Access Compliance Report

Public Rights-of-Way

(Curb Ramps)

Intersection ID: 21038	Main Street: BROCKTON_LN	Cross Street: PROVIDENCE_RD	Location: NW
ADA ID: 22D095F488DD	Ramp Type: PerpDiag	Initial Pass/Fail: Fail	Overall Compliance: No
			Severity Score: 21.25

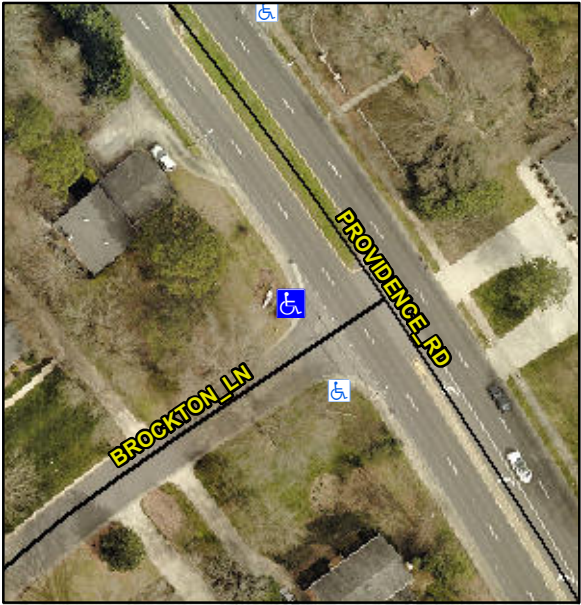
Codes/Mitigation Info/Possible Solution		Field Measurements/Component Compliance					
	Possible Solutions:						
	Remove & Replace Curb Ramp With Two New Directional Ramps or Equivalent.						
	Surveyor Notes:						
	N/A						
	PROW/ADA:						
	R304.5.1, R304.5.3						
		Compliance	Description	Data	Compliance	Description	Data
		N/A	Ramp Length (in)	59.0	Yes	Ramp Slope (%)	7.1
		No	Ramp Width (in)	37.0	No	Ramp XSlope (%)	6.5
		N/A	Flare Type LT	N/A	N/A	Flare Type RT	N/A
		N/A	Flare Slope LT (%)	N/A	N/A	Flare Slope RT (%)	N/A
		N/A	Flare Traversable LT?	N/A	N/A	Flare Traversable RT?	N/A
		N/A	Landing Length (in)	N/A	N/A	DWS Provided?	N/A
		N/A	Landing Width (in)	N/A	N/A	DWS Contrast?	N/A
		N/A	Landing Slope (%)	N/A	N/A	DWS Length (in)	N/A
		N/A	Landing X Slope (%)	N/A	N/A	DWS Full Width?	N/A
		N/A	Landing Curb? (Y/N)	N/A	N/A	DWS Offset (in)	N/A
		N/A	Shared Landing?	N/A			
		N/A	Gutter Ponding?	N/A	N/A	Gutter Slope (%)	N/A
